Safety Evaluation Report for the Lost Creek Project, Sweetwater County, Wyoming, Materials License No. SUA- 1598

Docket No. 40-9068
Lost Creek ISR, LLC

U.S. Nuclear Regulatory Commission

August 2011

Figure 2.2-2: Average Monthly Precipitation Collected at Various Stations

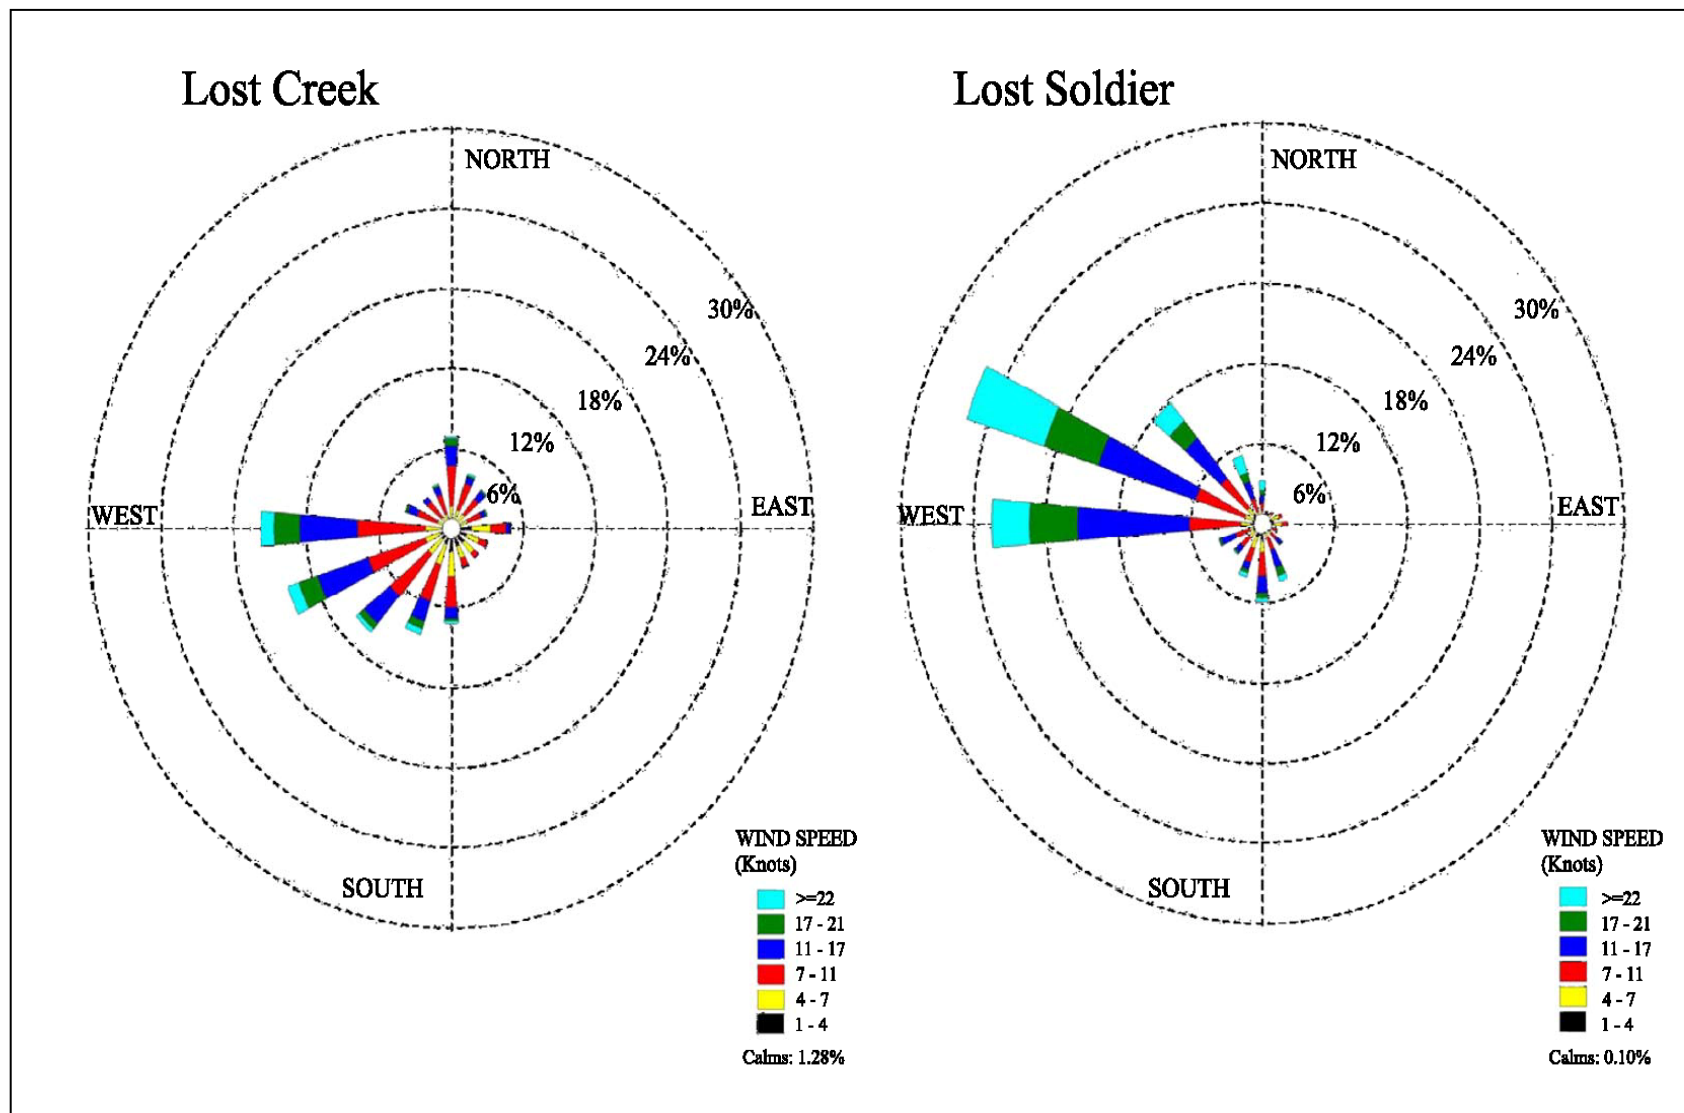
The applicant (LCI, 2010a) compared the average monthly precipitation and temperature data measured during various record periods at several sites to the precipitation and temperatures measured at the LS and LC stations as shown in SER Figure 2.2-2 and SER Table 2.2-1. Staff observed that these data presented do not verify that the data collected at Lost Creek or Lost Soldier are representative of long-term conditions because the periods of collection were not the same at the various sites. In addition, the staff found that it is difficult to compare average rainfall data because the data could have included years with exceptional rainfall or droughts.

Figure 2.6-3: Location of Radial Receptors from Plant Center

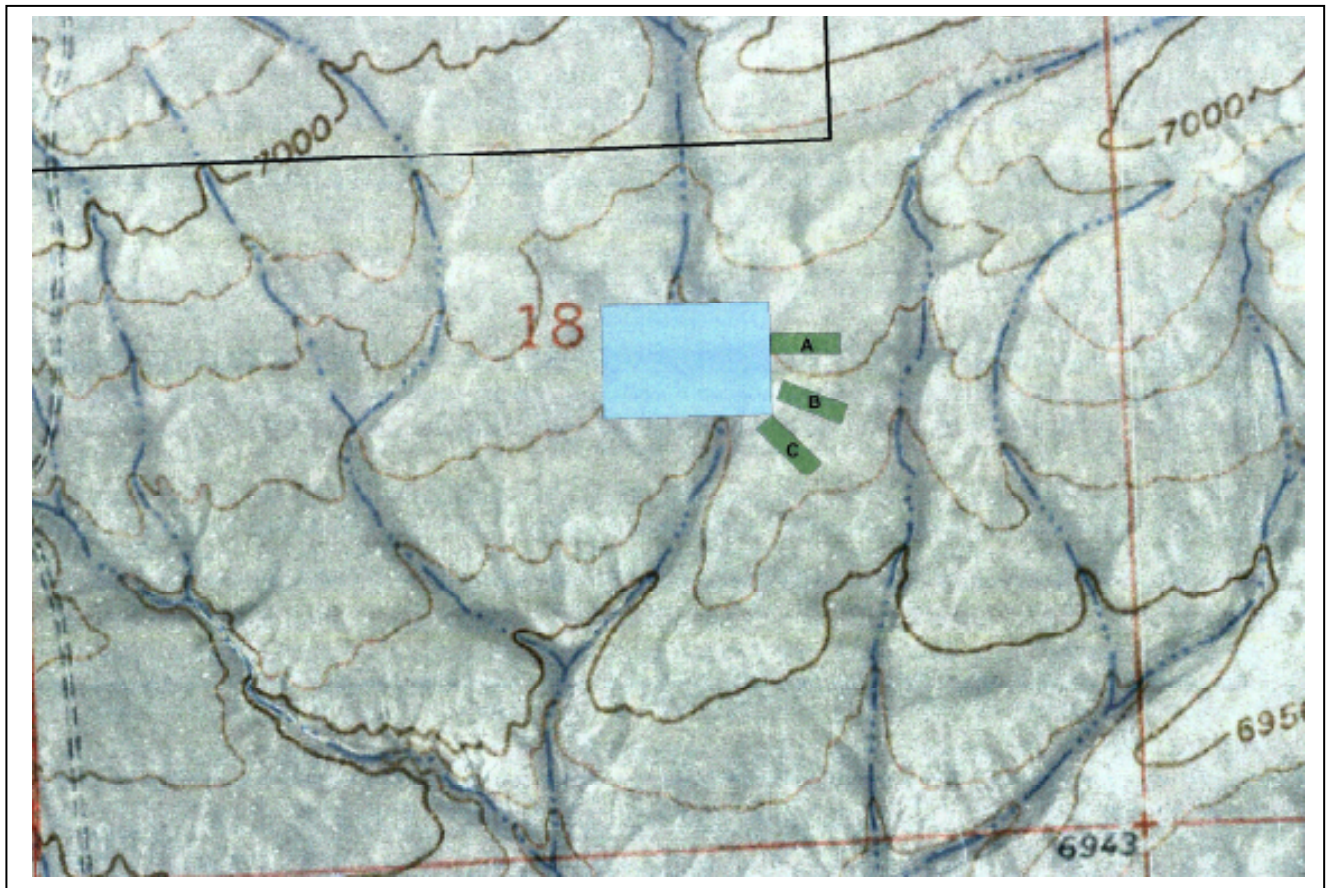
The applicant stated that four of the six highest predicted ground concentrations of radon progeny were within the boundary of the processing plant (square in SER Figure 2.6-3) (LCI, 2010a). The remaining two were outside of the plant-fenced area, but within the permit boundary north and east of the plant. These locations are annotated as N200 and E200, respectively, in SER Figure 2.6-2.

The applicant stated that air particulate samples will be collected continuously at the five locations identified in SER Figure 2.6-3 and analyzed for natural uranium, Th-230, Ra-226, and Pb-210 in accordance with Regulatory Guide 4.14. Sampler HV-2 is located approximately 200 m east of the plant at a location that the applicant's models predicted would have the highest soil deposition as described in section 2.9.4 of the technical report. Sampler HV-3 is located at a position that the applicant stated had the lowest total effective dose equivalent (TEDE) of any modeled receptor. Samplers HV-4 and HV-5 are located at receptor sites that the applicant stated the model predicted to be at intermediate concentrations and are downwind of the plant and wellfields.

Figure 2.6-5: 2009 Vegetation and Soil Sampling Locations

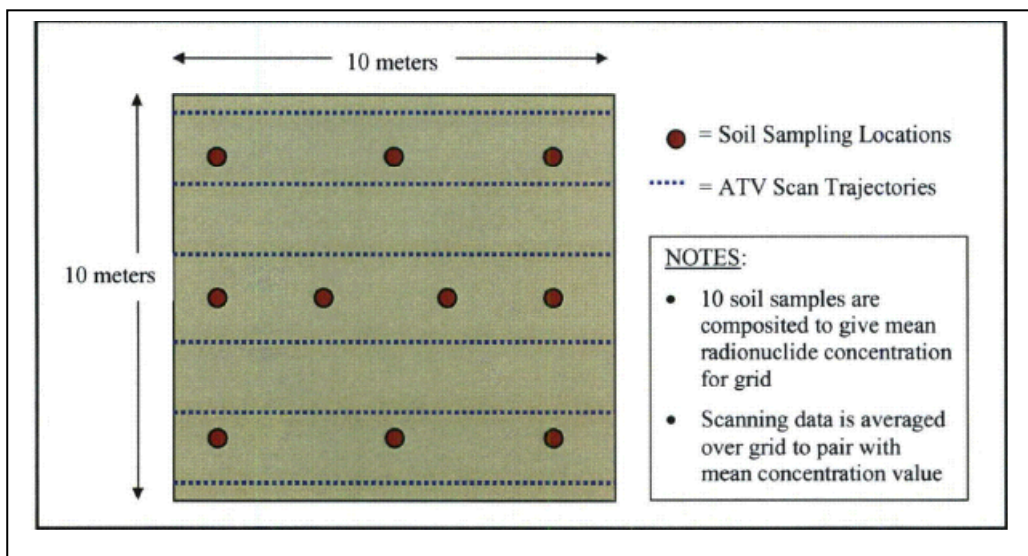
According to the applicant (LCI, 2010a), sampling locations D and E within the plant boundary in SER Figure 2.6-5 were predicted by MILDOS-AREA modeling to have the most ground concentrations of radon progeny during operations. Locations F, G, H, and I (see SER Figure 2.6-5) were areas that the direct gamma scan survey (described in SER Section 2.6.3.4) indicated elevated gamma activity. The applicant stated that location J (see SER Figure 2.6-5) measured background exposure readings in the baseline direct gamma scan survey and was upwind during operations where MILDOS-AREA modeling predicts radon deposition to be low or non-existent (LCI, 2010a). The NRC staff finds that the applicant collected and analyzed the revised baseline vegetation sampling consistent with Regulatory Guide 4.14 because the applicant sampled forage vegetation at least three times during the grazing season in grazing areas in three different sectors having the highest predicted airborne radionuclide concentration due to milling operations, as recommended in the regulatory guide.
